L. D. Moody, Cumberland Fossil Plant

CUMBERLAND FOSSIL PLANT (CUF) - INSPECTION OF WASTE DISPOSAL
AREAS

K. W. Burnett, LP 2G - C

CUMBERLAND FOSSIL PLANT - INSPECTION OF THE WASTE DISPOSAL AREAS

ASH DISPOSAL AREAS

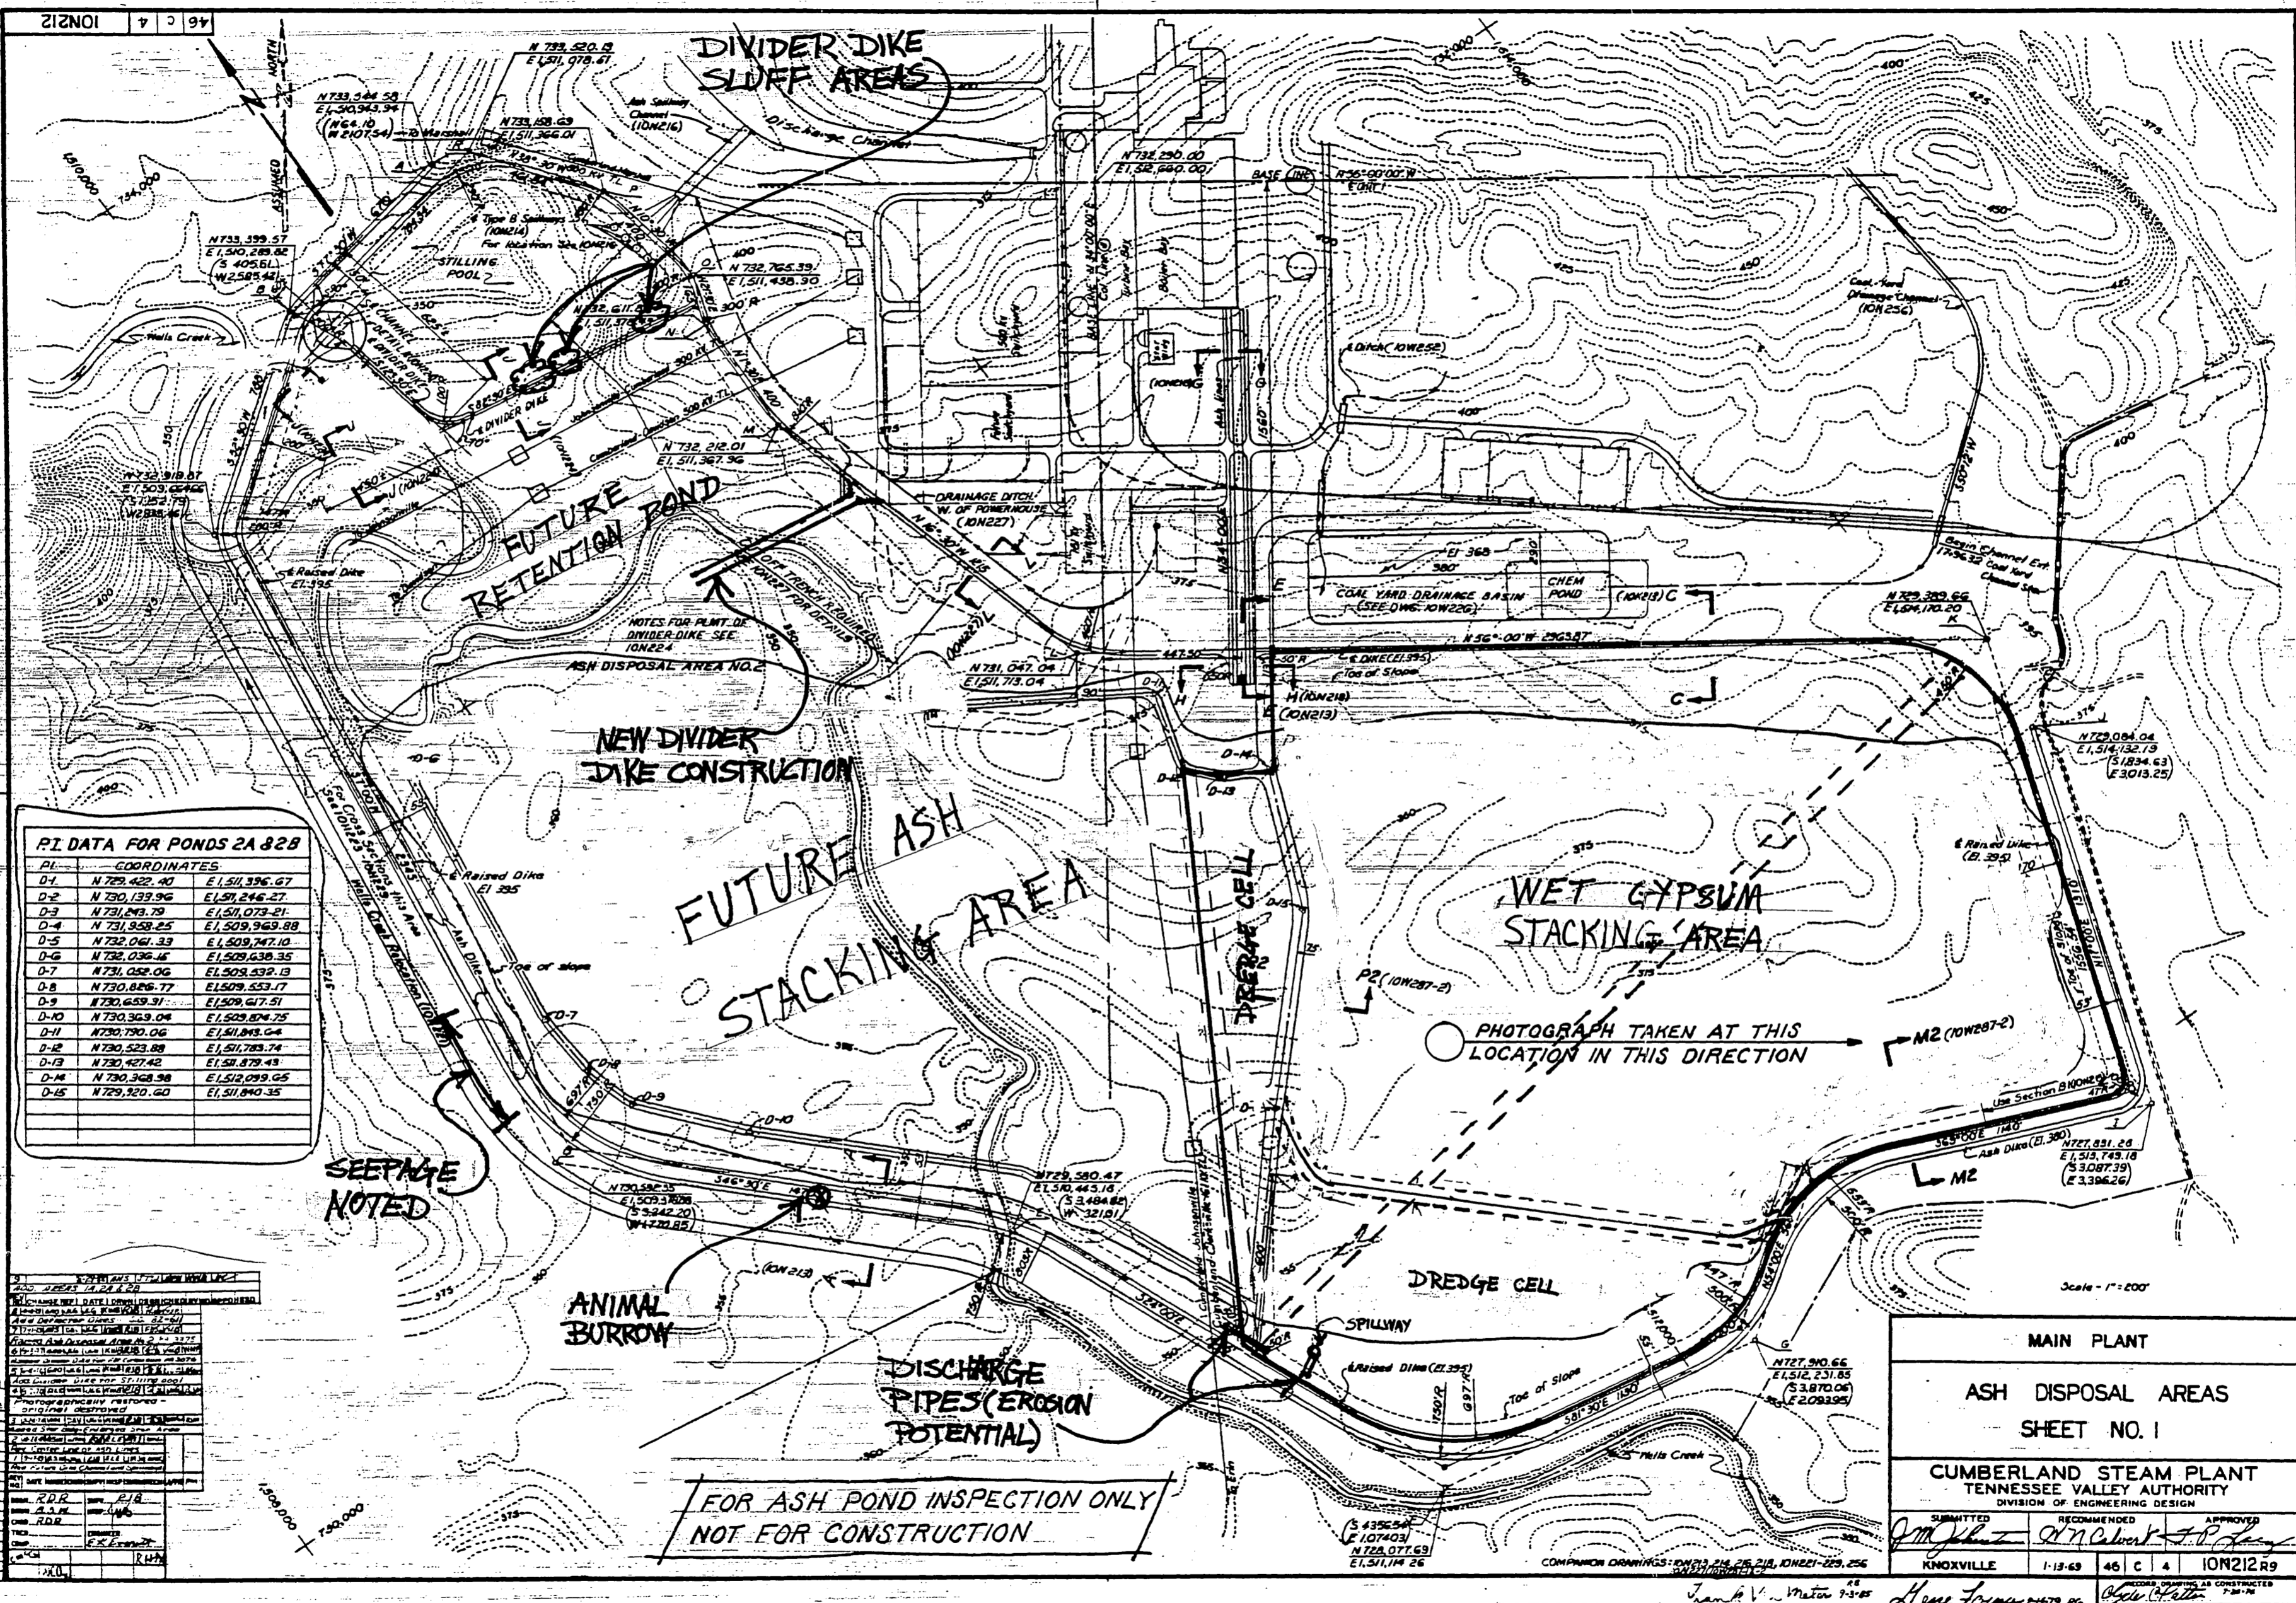
- 1.1 This inspection of the waste disposal areas was conducted on March 15, 1995.
- 1.2 The last inspection was conducted on June 8, 1994.
- 1.3 This was a joint inspection by representatives of Fossil Fuels and Fossil Engineering (FE). The inspection was performed by Jim Huber, Fossil Fuels; Jerry Glover, FE; and Keith Elder, FE.
- 1.4 Our findings during this inspection were not discussed with plant personnel the day of the inspection due to completion late in the day. Jim Huber discussed our observations and recommendations with Jeff Cummings, Yard Operations Supervisor, and Gene Leslie, Heavy Equipment Foreman, the following day (March 16).
- 1.5 The areas referenced in the report are shown on the attached print of drawing 10N212.

- 2.1.1 The exterior dike was in excellent condition. No visible signs of instability were noted. A few areas contained growth of small trees and rose bush. (See recommendation 6.1)
- 2.1.2 The access roads along the top of the exterior dike are in fair condition with sporadic areas of rutting. (See recommendation 6.2)

2.1.3 Two discharge pipes in the southwestern portion of this area are creating potential problems for the exterior dike. One pipe is discharging water from the dredge cell in the southern portion of the area into the perimeter ditch between the gypsum starter dike and the exterior dike. The other pipe is approximately 100 feet west of this pipe and is discharging into area no. 2. Discharge from both pipes is eroding the interior slope of the exterior dike. (See recommendation 6.3)

3.1.2 The divider dike between the active ash disposal pond and the stilling pool has an excellent cover of riprap, but three separate areas on the stilling pool side of the dike were sluffing into the water. These areas could grow in size and cause structural problems in the dike later. (See recommendation 6.4)

3.1.3 Several small trees and patches of rose bush were present on the outer slope of the exterior dike. A small patch of trees was also noted on the inside of the dike in the southern portion of this area. (See

- 3.1.4 An animal burrow was found on the south exterior dike. It was approximately 1 foot in diameter and 3 feet deep and was located approximately 30 feet west of the piezometer tube on the south dike just above the elevation 380 berm. (See recommendation 6.5)

- 3.1.5 Areas of seepage were noted along the bank of the Wells Creek channel in the vicinity of the construction access bridge. The seepage appeared to be greater than in recent observations and extended approximately 50 feet upstream (east) of the bridge and 100 to 150 feet downstream of it. The increased seepage was probably due to the temporarily increased water level in the ash pond (See recommendation 6.6) There were no signs of dike structural instability in this area.

6.1 Remove the small trees and rose bush from the exterior dike slopes (Reference 2.1.1 and 3.1.3) above the berm (top of original dike) at elevation 380 ft. They should be pulled out so as to remove their root systems.

6.2 Cover the rutted areas in the dike road with a layer of at least 4" of crushed stone. (Reference 2.1.2)

6.3 Riprap the areas around the discharge pipes in the southwest corner of the wet gypsum stacking area (Reference 2.1.3).

6.4 Repair the three sluffed areas on the stilling pool side of the divider dike (Reference 3.1.2). Riprap should be placed in the sluffed areas with a back hoe or equivalent device until the slope is again continuous.

6.5 Repair the animal burrow on the south exterior dike. Fill it with earth and compact it (Reference 3.1.4).

- 6.6 Continue to carefully monitor the seepage along the banks of Wells Creek. If seepage increases or problems are noted, please notify Site and Environmental Engineering immediately.
